UNITED STATES PATENT AND TRADEMARK OFFICE

Office Action Summary	Application No. 10/697,404	Applicant(s) WILLEMS ET AL.
	Examiner Tony H. Winner	Art Unit 3611

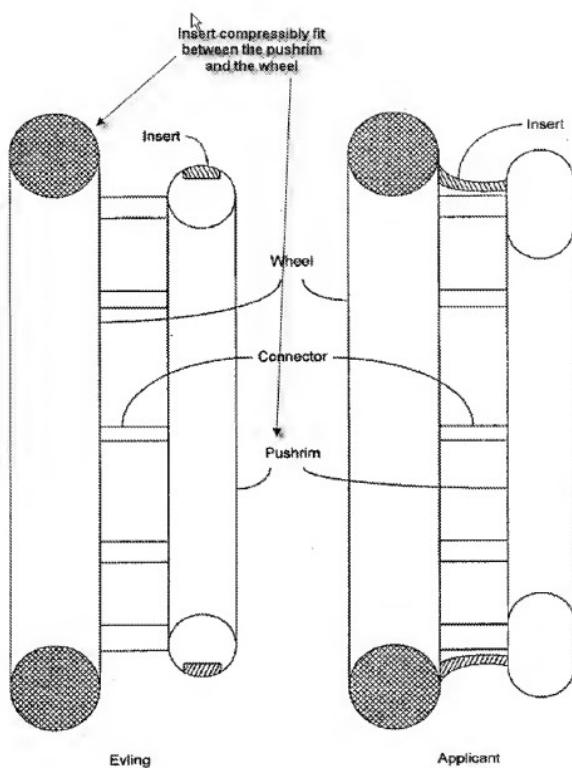
Evling discloses a wheelchair pushrim system (figures 1 and 4) comprising:

- a. a hollow and smooth pushrim (abstract 22 and 24);
- b. a wheel (92) connected to the pushrim;
- c. a connector (94) connecting the pushrim to the wheel; and
- d. an elastic insert (100 and col 5 lines 59) compressibly fit between the pushrim and the wheel (see illustration);
- d. wherein the elastic insert can also be made out of rubber or neoprene, or silicon (col 5 lines 59).

Response – as illustrated in the drawings above, the insert is fitted between the rim and the wheel.
